[Docket No. 2002-SW-55-AD; Amendment 39-13060; AD 2002-25-51]

Airworthiness Directives; Agusta S.p.A. Model A109E Helicopters

2002-25-51 Agusta S.p.A (Agusta): Docket No. 2002-SW-55-AD. Supersedes AD 2002-17-51, Amendment 39-12936, Docket No. 2002-SW-42-AD.

FIGURE 1

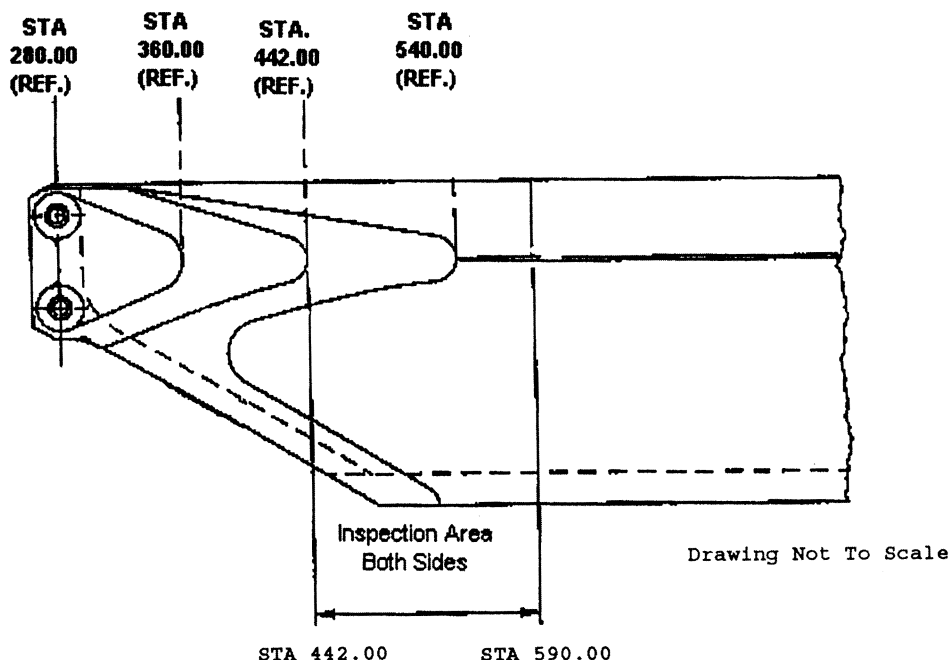
(b) Before each start of the helicopter engines, visually check both sides of each tail rotor blade for a crack in the area depicted in Figure 1 of this AD. An owner/operator (pilot) holding at least a private pilot certificate may perform this visual check and must enter compliance with this paragraph into the aircraft maintenance records in accordance with 14 CFR 43.11 and 91.417(a)(2)(v). See Figure 1:

(h) Before each start of the helicopter engines, visually check both sides of each tail

rotor blade for a crack in the area depicted in Figure 1 of this AD. An owner/operator (pilot) holding at least a private pilot certificate may perform this visual check and must enter compliance with this paragraph into the aircraft maintenance records in accordance with 14 CFR 43.11 and 91.417(a)(2)(v). See Figure 1.
